Access Compliance Report

Public Rights-of-Way (Curb Ramps)

Intersection ID: 10031554	Main Street: MEACHAM_ST	Cross Street: N/A	Location: NW
ADA ID: 37409A5E017E	Ramp Type: Directional1	Initial Pass/Fail: Fail	Overall Compliance: No
		Severity Score: 8.75

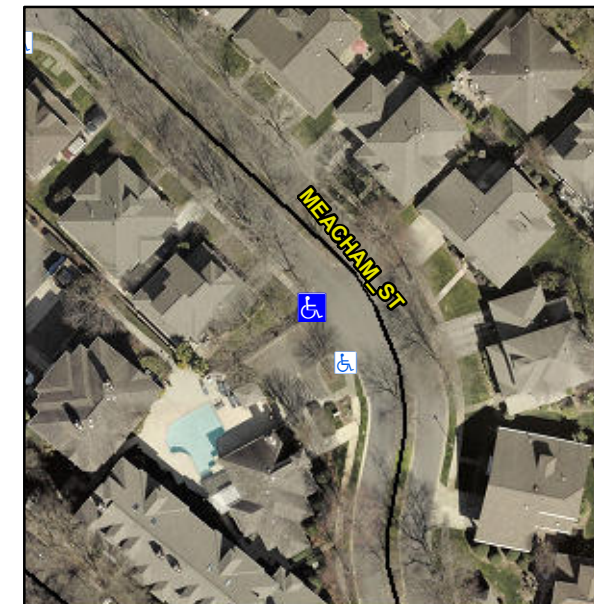
R304.5.1

Compliance	Description	Data	Compliance	Description	Data
N/A	Ramp Length (in)	49.0	N/A	Grade Break?	N/A
No	Ramp Width (in)	38.0	N/A	Grade Break Slope (%)	0.0
Yes	Ramp Slope (%)	5.8	N/A	Grade Break XSlope (%)	0.0
Yes	Ramp XSlope (%)	1.1			
N/A	Flare Type LT	N/A	N/A	Flare Type RT	N/A
N/A	Flare Slope LT (%)	N/A	N/A	Flare Slope RT (%)	0.0
N/A	Flare Traversable LT?	N/A	N/A	Flare Traversable RT?	N/A
N/A	Landing Length (in)	0.0	N/A	DWS Provided?	N/A
N/A	Landing Width (in)	0.0	N/A	DWS Contrast?	N/A
N/A	Landing Slope (%)	0.0	N/A	DWS Length (in)	N/A
N/A	Landing X Slope (%)	0.0	N/A	DWS Full Width?	N/A
N/A	Landing Curb? (Y/N)	N/A	N/A	DWS Offset LT (in)	N/A
N/A	Shared Landing?	N/A	N/A	DWS Offset RT (in)	N/A
N/A	Gutter Ponding?	0.0	N/A	Gutter Slope (%)	N/A
N/A	Gutter Lip Ht (in)	0.0	N/A	Gutter X Slope (%)	N/A
N/A	Painted X Walk1?	No		Road Slope (%)	0.2
	X Walk 1 Direction	To SE		Road X Slope (%)	2.7
	X Walk 1 Width (in)	N/A		Clear Space?	N/A

X Walk 1 Slope (%)	0.2	N/A	Clear Space to XWalk (in)	N/A
	X Walk 1 X Slope (%)	2.7	N/A	Storm Grate/Utility Hazard?	N/A
N/A	Ramp inside XWalk1?	N/A		Storm Grate/Utility Type	
N/A	Any Obstructions?	N/A			N/A
	Obstruction Type		Yes	Surface Condition? (G/P)	Good
			N/A	Curb Slope (%)	5.0

Remove & Replace Entire Ramp.
